Title: ERID-111328 SUBMITTAL OF THE RESPONSE TO THE NOTICE OF DISAPPROVAL FOR THE INVESTIGATION WORK PLAN FOR LOWER PAJARITO CANYON AGGREGATE AREA AND REVISION 1, INCLUDING 2 CD'S, EP2010-0521, EP2010-0522, LA-UR-10-7635

To:(Addressees - Organization) JAMES BEARZI, NMED

From:(Senders - Organization) MICHAEL J GRAHAM, LANL
 GEORGE J RAE, DOE

Figure 4.7-3 Organic chemicals detected at SWMU 18-003(c)

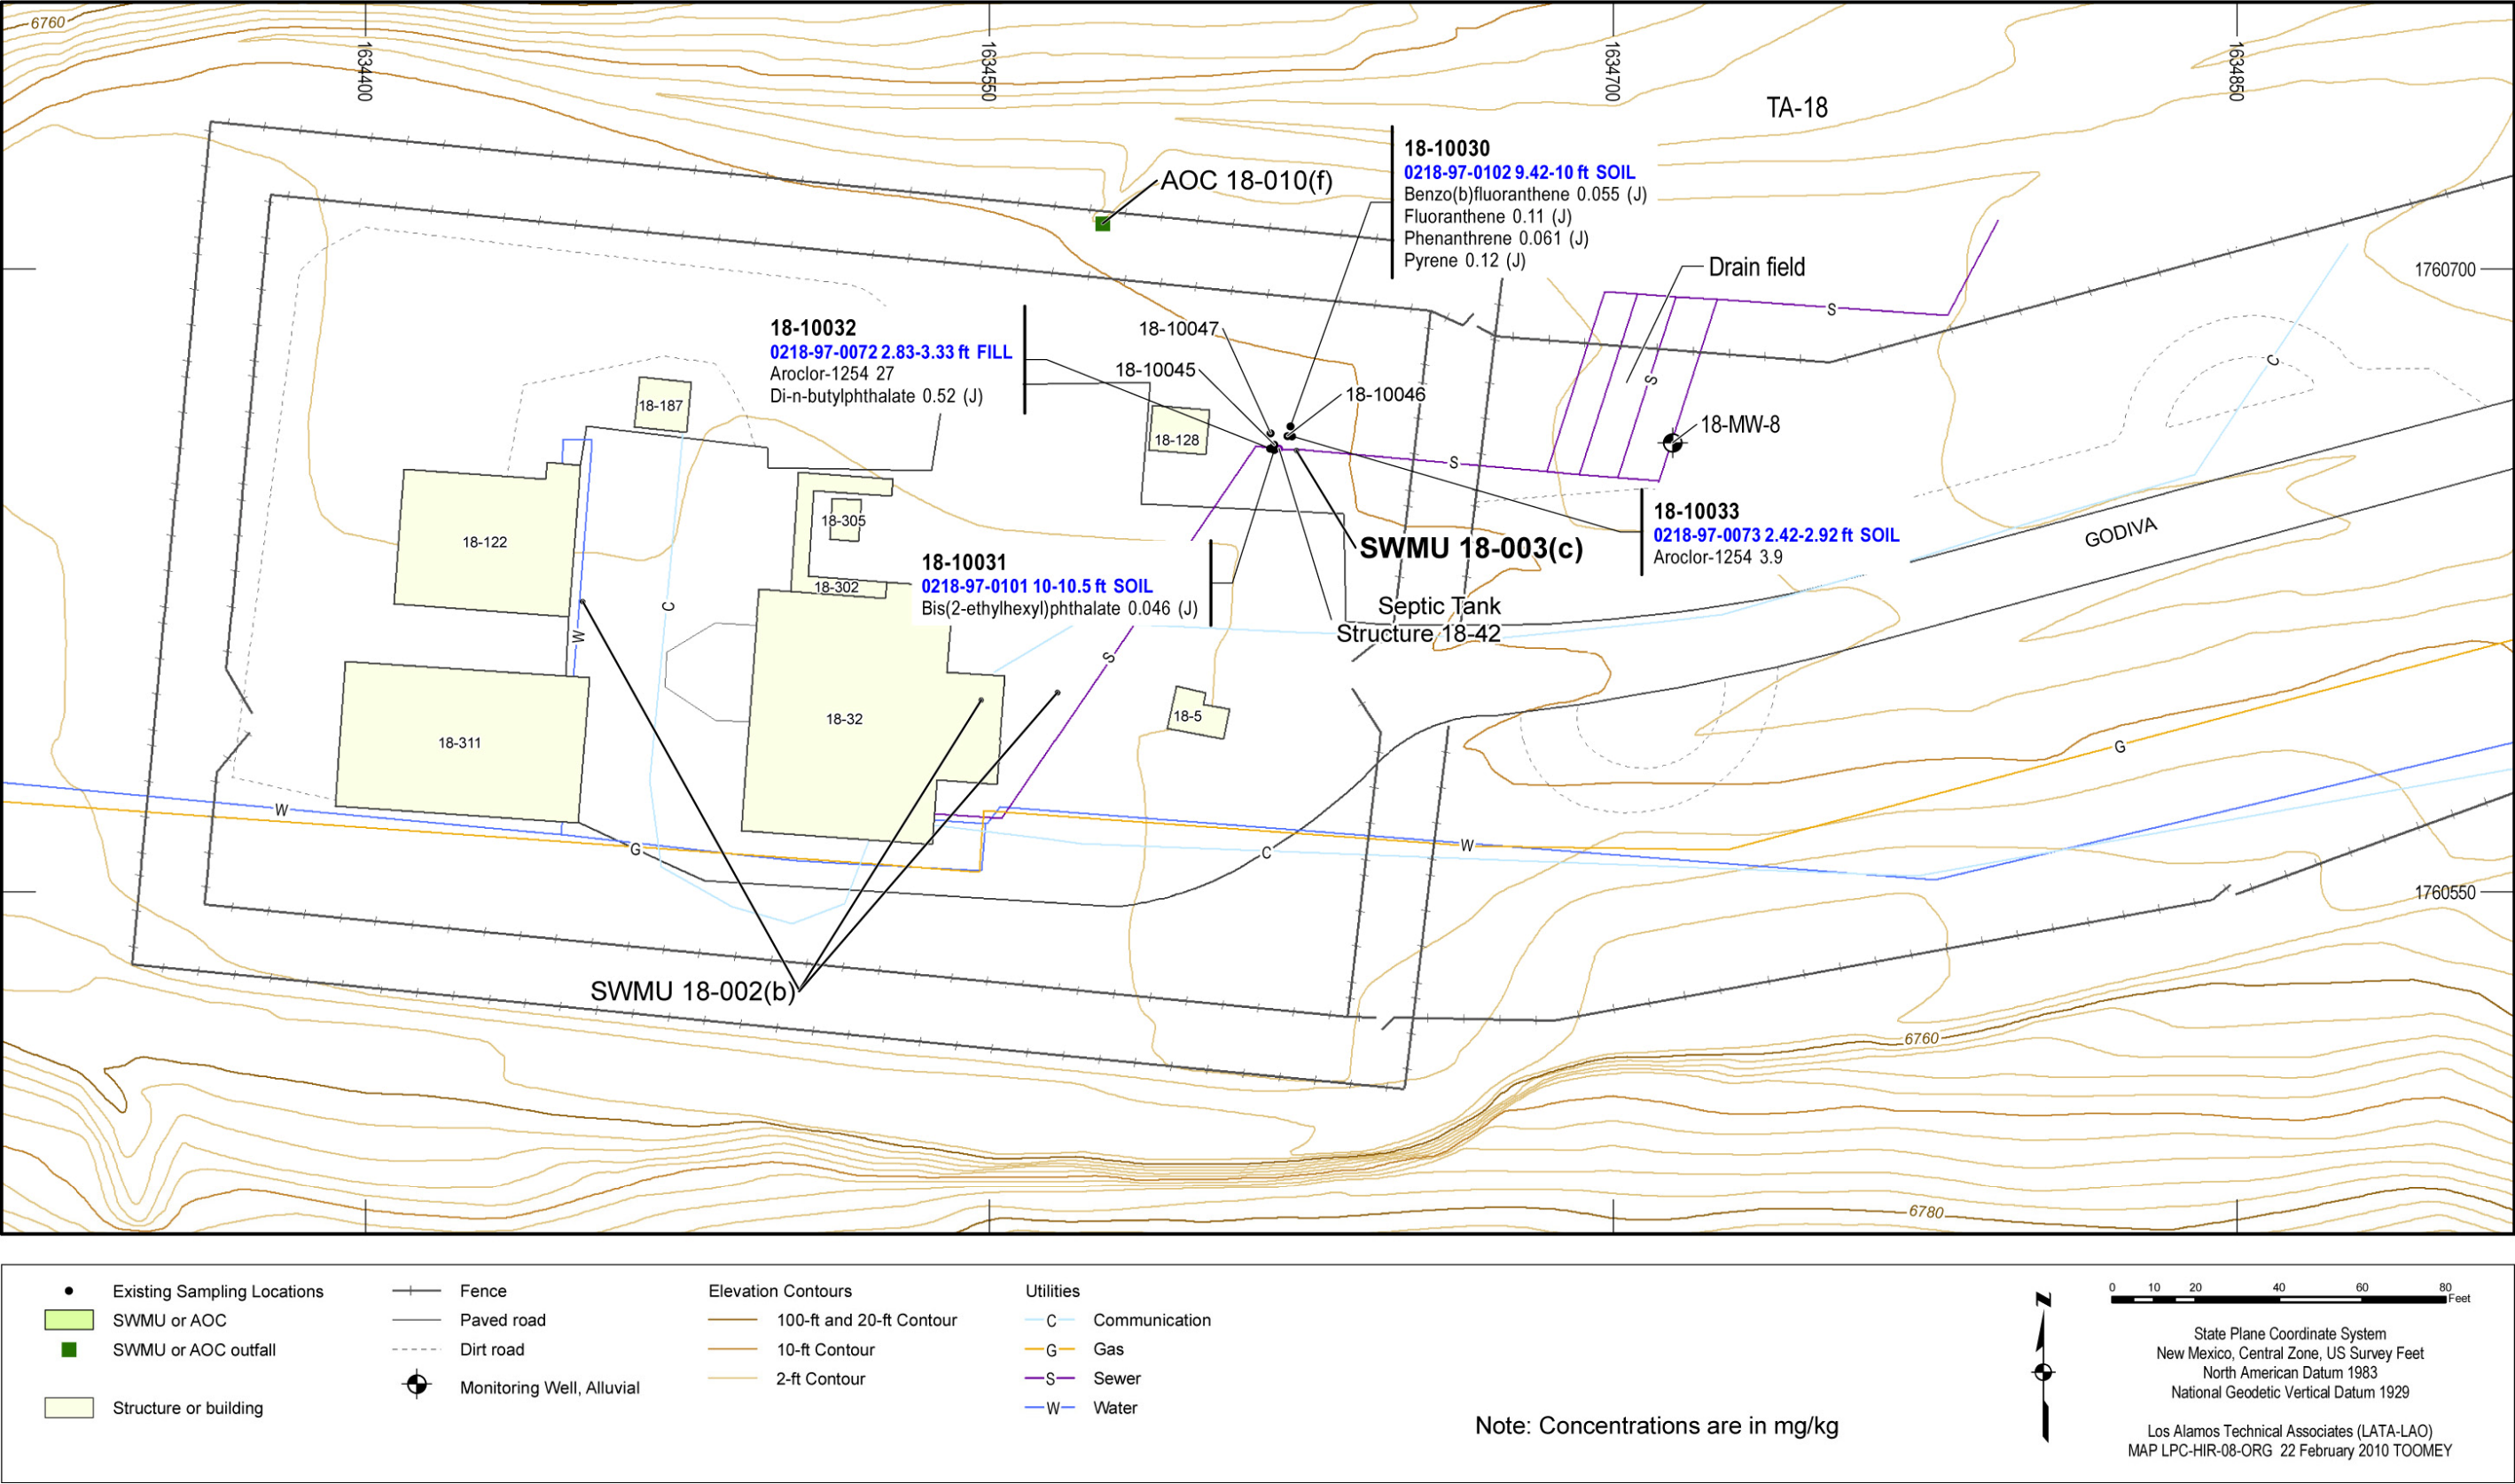
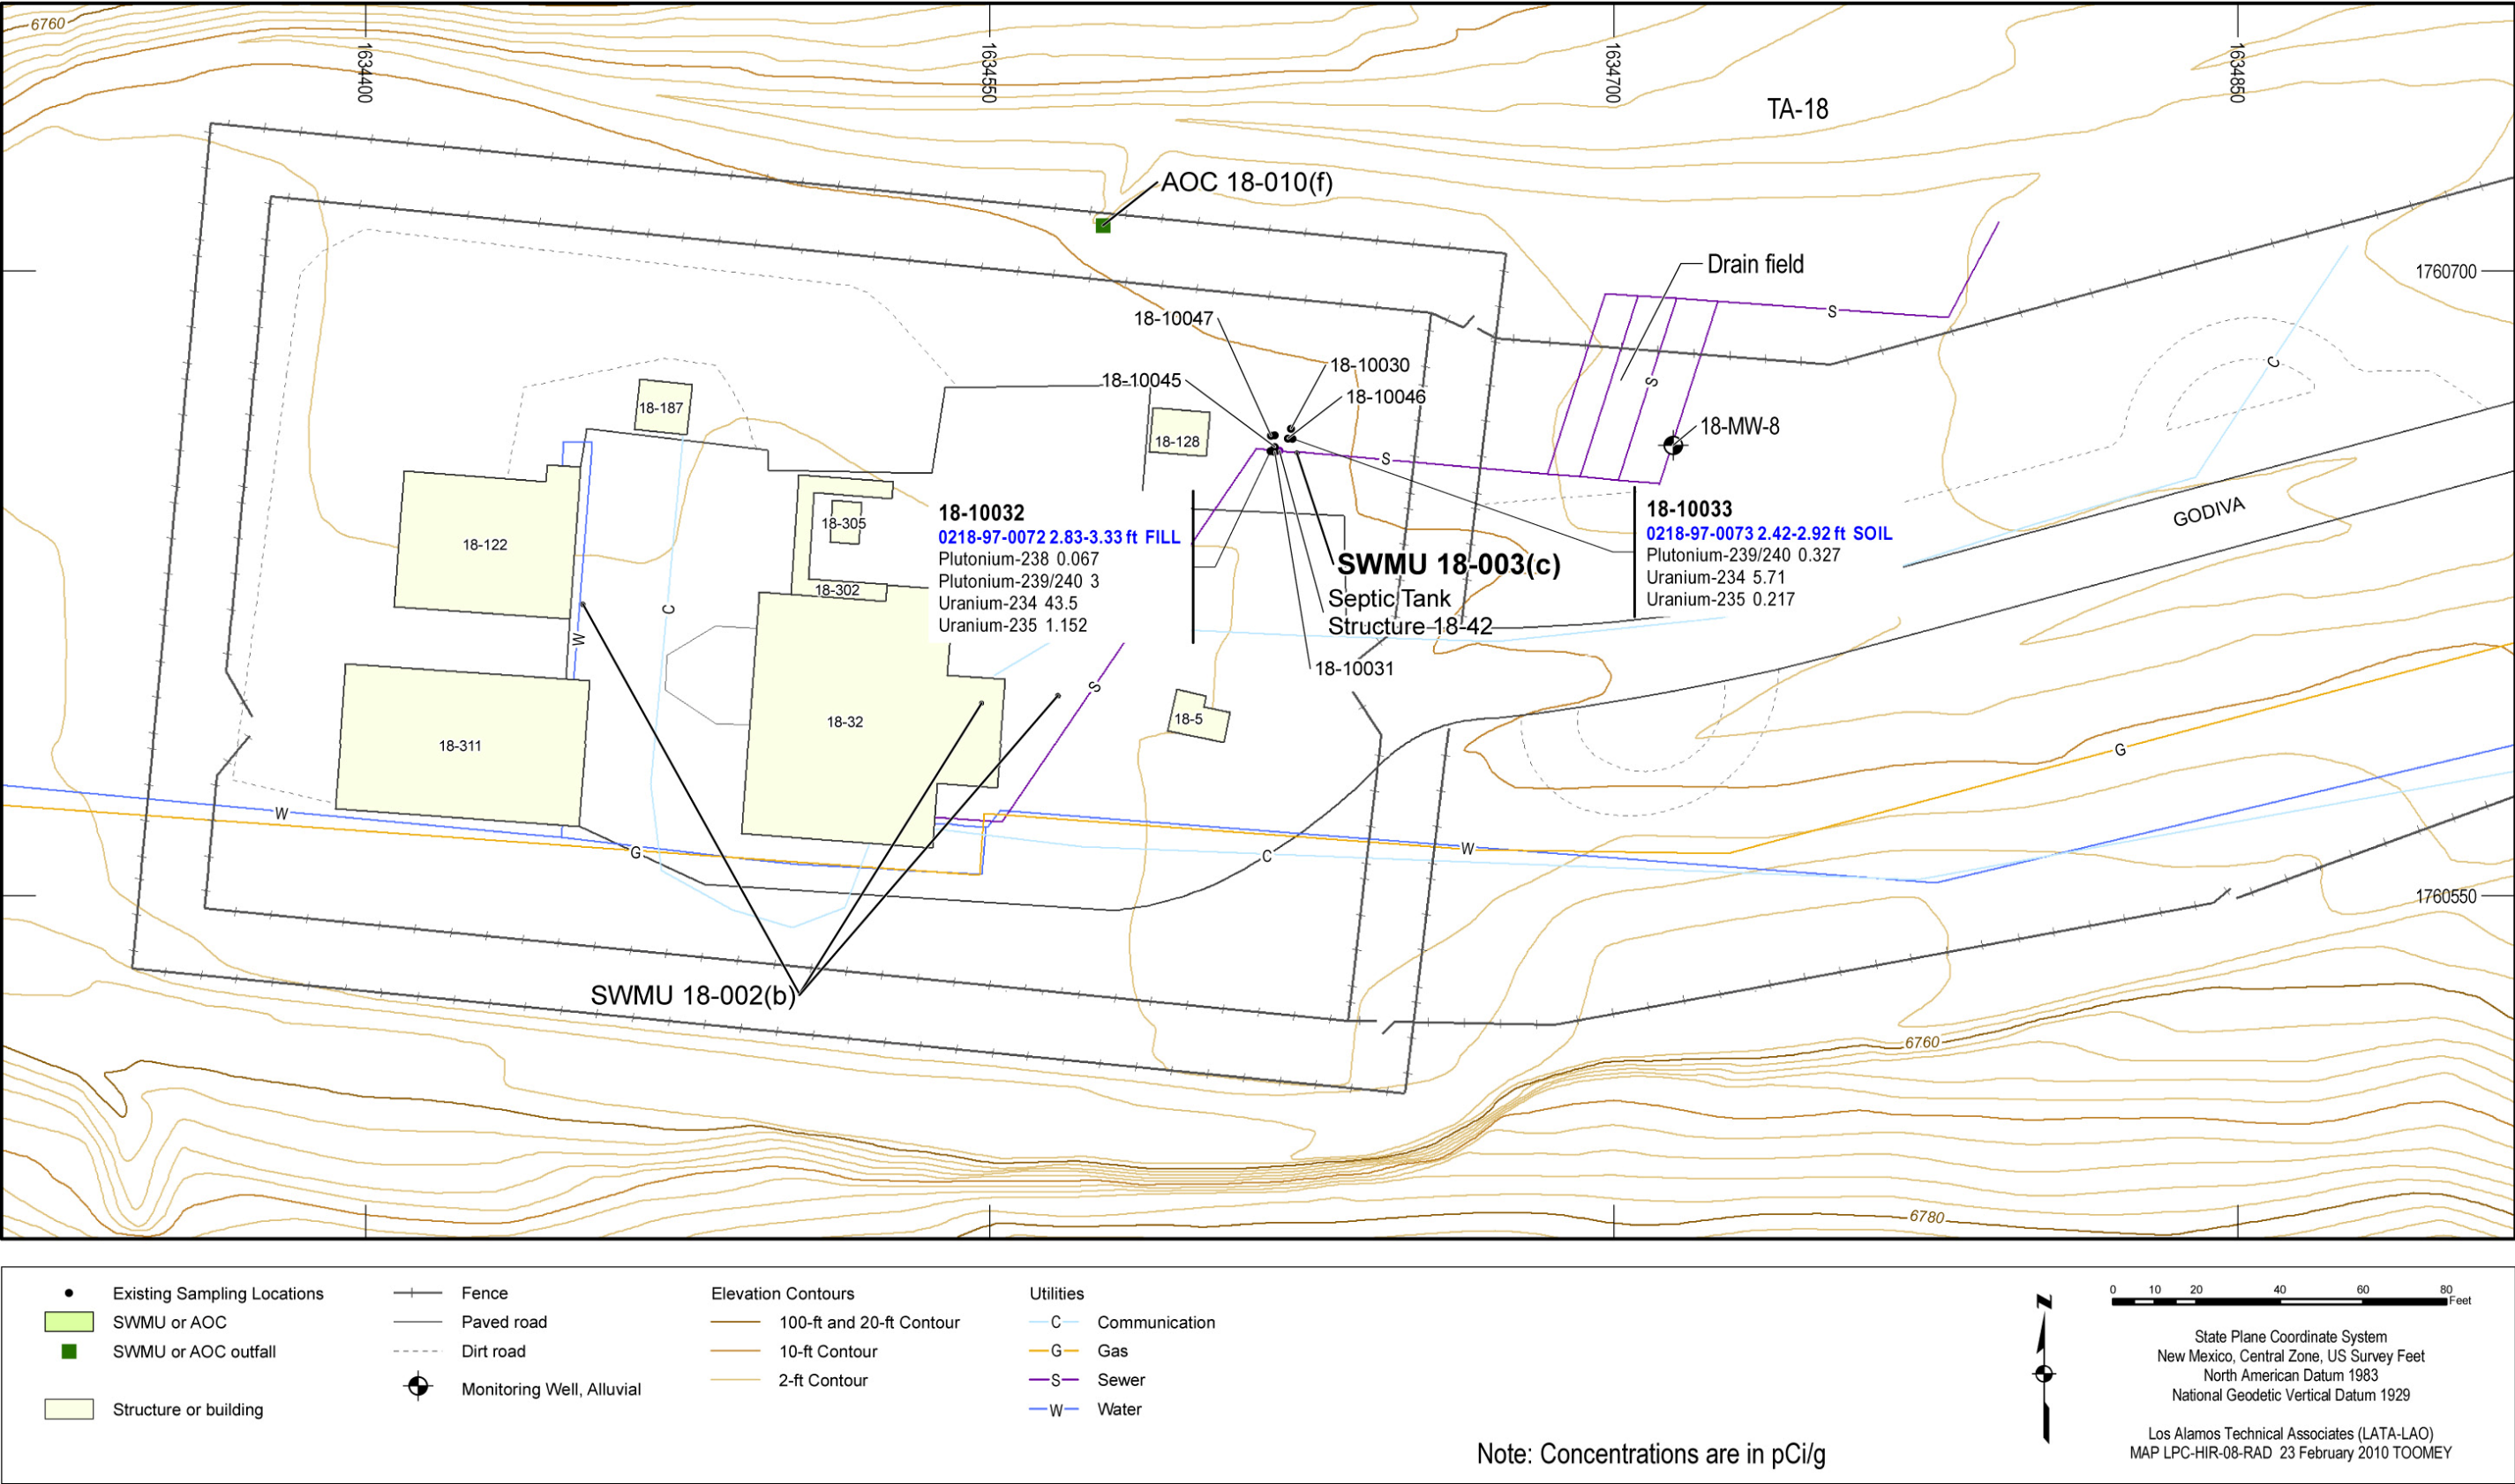
NMED Comment: Plan Plate 1 depicts a well located near SWMU 18-003(c). The well is identified as 18-MW-8 on Plate 1. Verify that well M-8 is the same well as 18-MW-8. Show the well location on

Figures 4.7-1 through 4.7-5, inclusive. According to Table 5.4-1 of the 2010 Interim Facility-Wide Groundwater Monitoring Plan, well 18-MW-8 is an alluvial well that is sampled annually for Target Analyte List (TAL) metals, volatile and semi-volatile organic compounds including tentatively identified compounds (VOCs, SVOCs and TICs, respectively), explosive compounds, radionuclides, several general inorganic analytes, perchlorate and various field indicator parameters. NMED internal correspondence indicates the well was scheduled for sampling in August 2010. If well 18-MW-8 is sampled in 2011, the Permittees must include that analytical data in the IR.

9. The text has been revised (section 4.7.1) to refer to well M-8 as well 18-MW-8, the current Laboratory designation for the well. Figures 4.7-1 through 4.7-5 have been revised to show the well as well 18-MW-8.

- 10. Section 4.7.3, Scope of Activities SWMU 18-003(c), second and third paragraphs, pages 24 and 25, Figure 4.7-3, page 86, Figure 4.7-5, page 88, and Tables 4.7-1 and 4.7-3, pages 148 and 149:**

Although the text indicates that locations chosen for sampling will be placed to coincide with the expected locations of pipe joints, review of Figure 4.7-5 indicates no sample locations have been proposed where the drain line exits Building 18-32, at the 45 degree bend located approximately 20 feet east of the building, or at the 45 degree bend located approximately 15 feet east of Building 18-128. The Permittees must either propose additional sample locations to evaluate the pipe joints or consider adjusting currently proposed locations to evaluate the joint locations.

The text in section 4.7.3, Figure 4.7-5, and Table 4.7-5 have been revised to include three additional proposed sampling locations. One location has been added where the drainline exits building 18-32; one location has been added at the 45-degree bend approximately 20 ft east of the building; and one location has been added at the 45-degree bend approximately 15 ft east of building 18-128.
